### **STAFF REPORT**

**APPLICATION RZ 2015-HM-005**

**HUNTER MILL DISTRICT**

<b>APPLICANT:</b>	Pulte Home Corporation
<b>EXISTING ZONING:</b>	I-4 (Medium Intensity Industrial)
<b>PROPOSED ZONING:</b>	R-30 (Residential, 30 du/ac)
<b>PARCEL:</b>	18-3 ((6)) 5
<b>SITE ACREAGE:</b>	1.58 acres
<b>PROPOSED OPEN SPACE:</b>	19%
<b>PLAN MAP:</b>	Residential Mixed Use
<b>15.2-2303.4 STATUS:</b>	Exempt: Reston
<b>PROPOSAL:</b>	To rezone from the I-4 District to the R-30 District to permit a total of 44 multi-family dwelling units at a density of 27.8 dwelling units per acre (du/ac)

Drawing Title: **Landscape Plan**

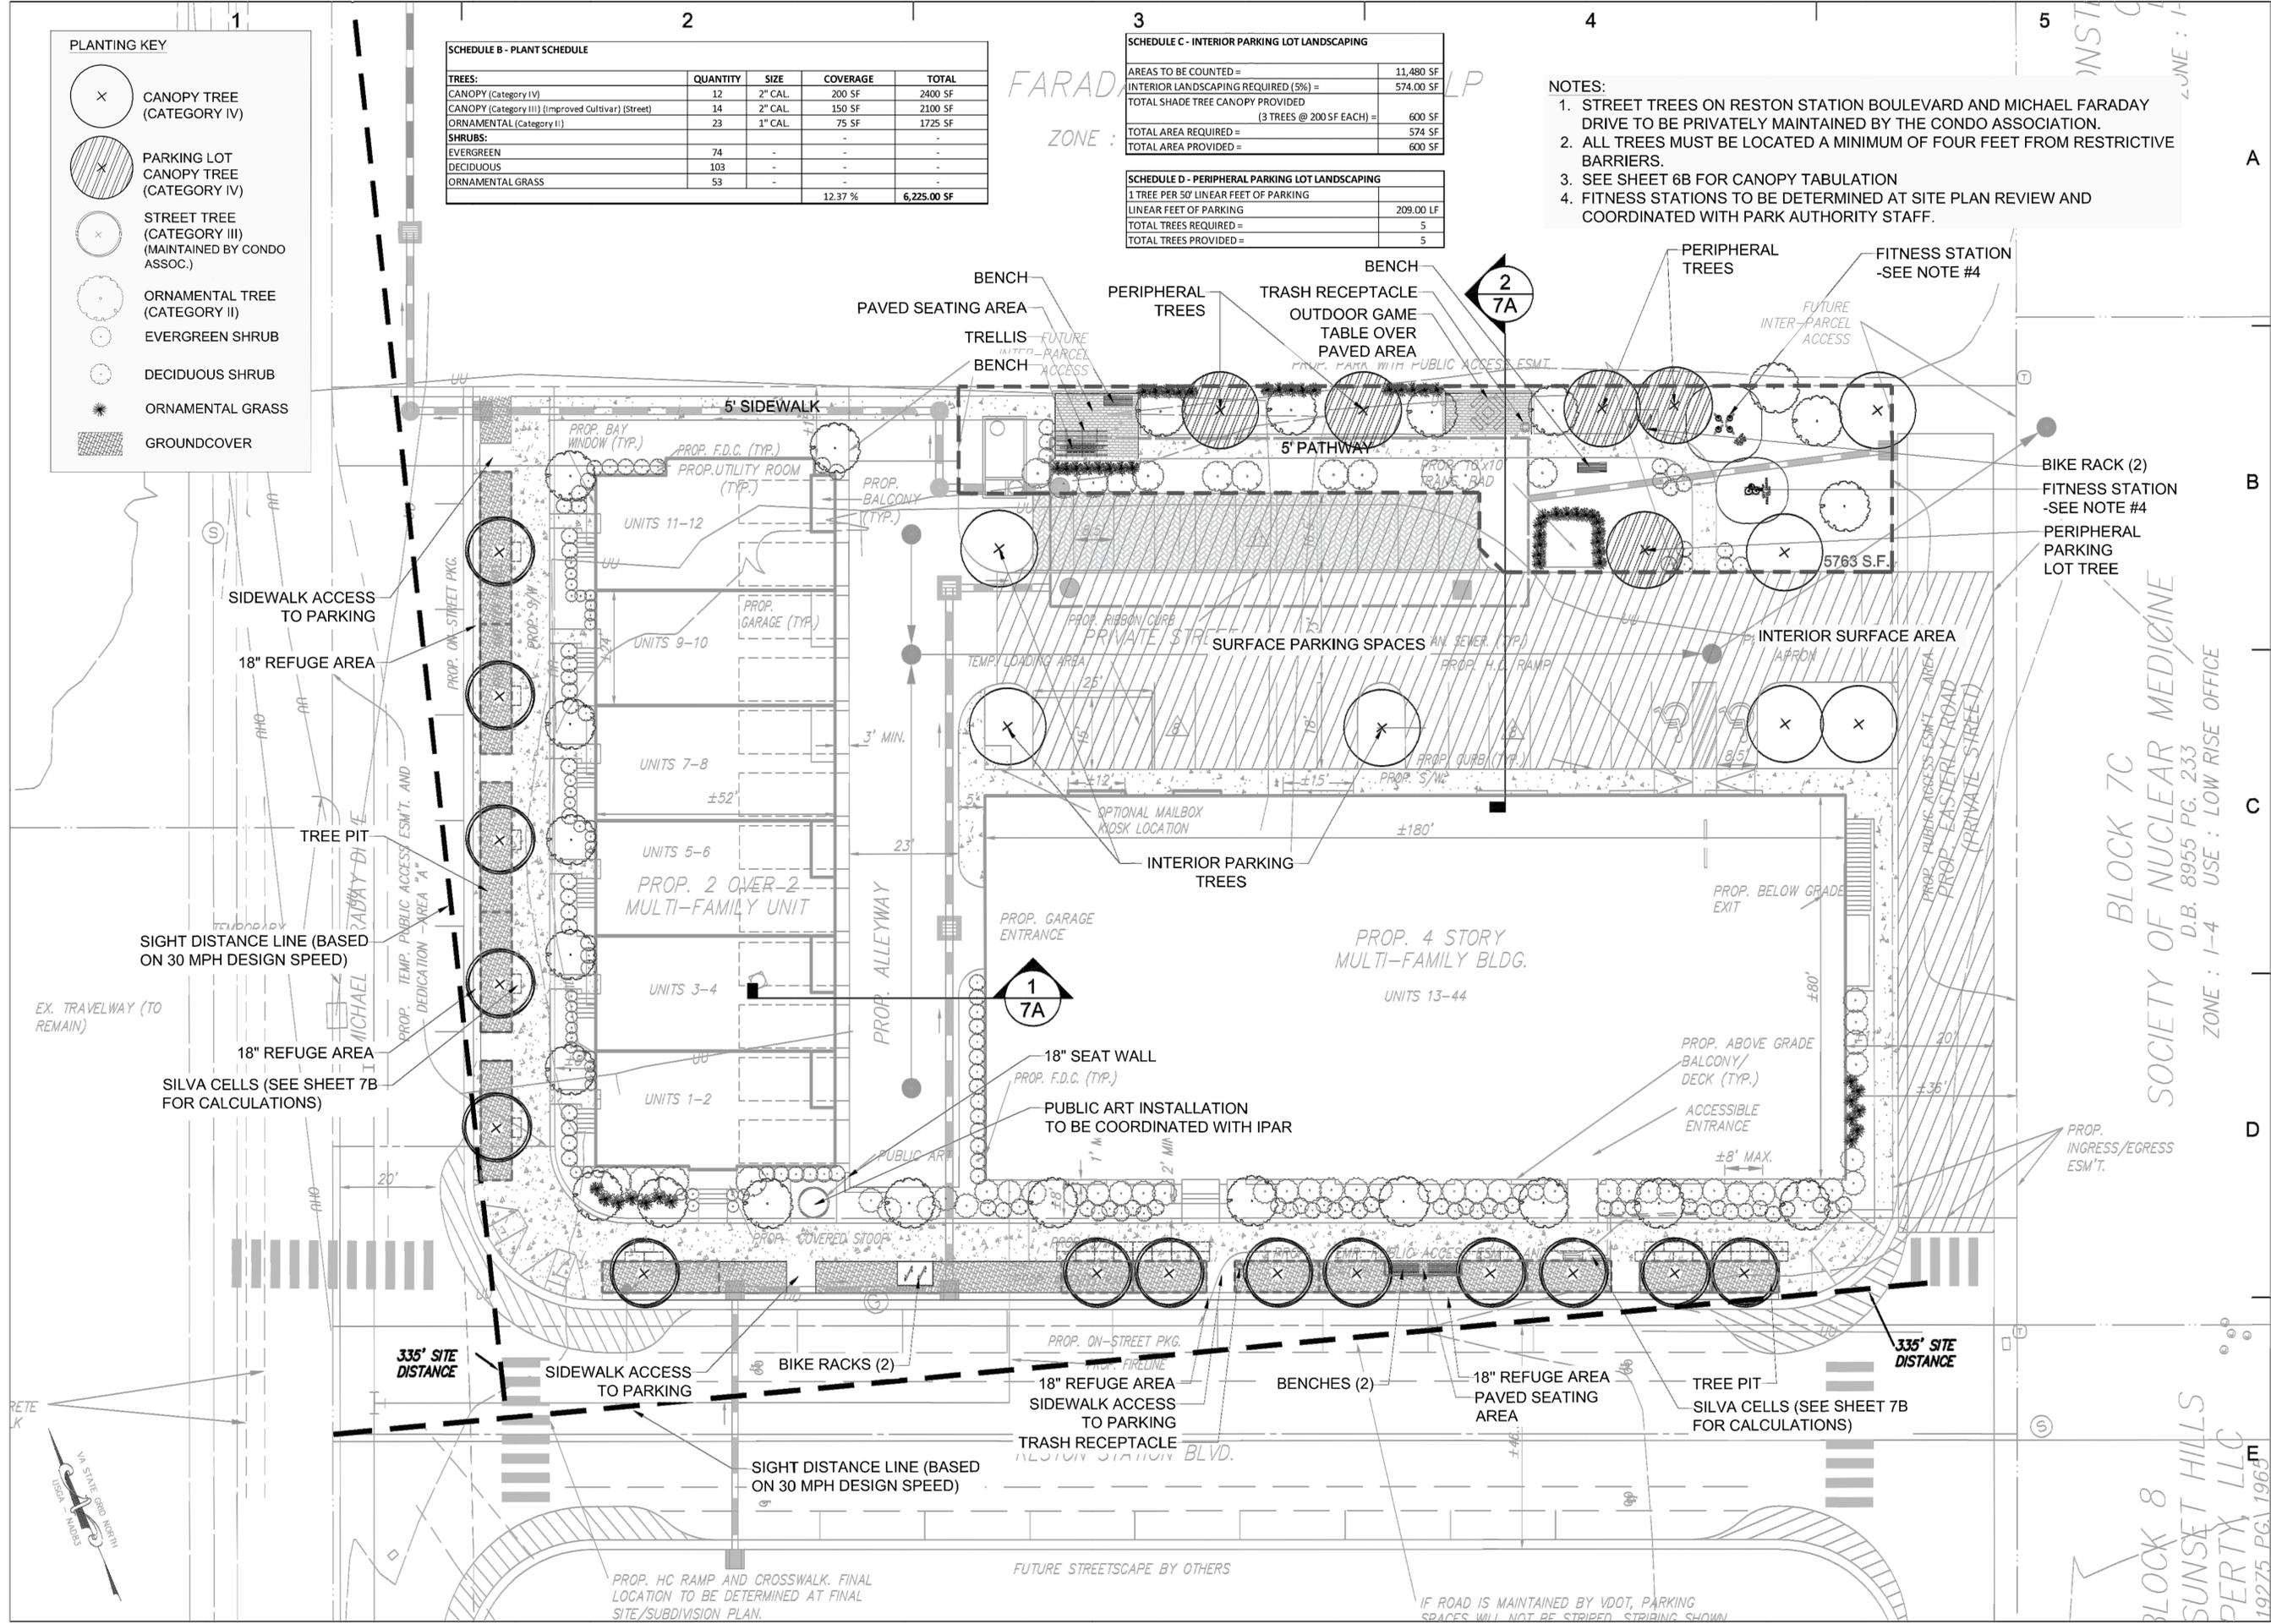
Applying the above urban parkland standard to the proposed development and assuming an average household size of 1.75, there is a need for 0.12 acres (about 5,227 square feet) of public urban park space onsite. Sheet 7 shows an onsite pocket park/open space area behind the multifamily building and adjacent to surface parking that includes a paved seating area with one bench and a trellis, another small paved area with an outdoor game table, two outdoor fitness stations, and a 5' wide pathway that connects to Michael Faraday Drive. Draft Proffer 23 references the onsite pocket park, but only provides a commitment to include two benches. Staff requests commitment to provide the active recreation facilities as shown on the CDP.

*Evaluation:* The proposed development generates a need for about 5,227 square feet of public urban park space onsite. Sheets 1 and 7 show an onsite pocket park/open space area behind the multifamily building and adjacent to surface parking that includes a few small active recreation facilities. Staff requests commitment to provide the active recreation facilities as shown on the CDP.
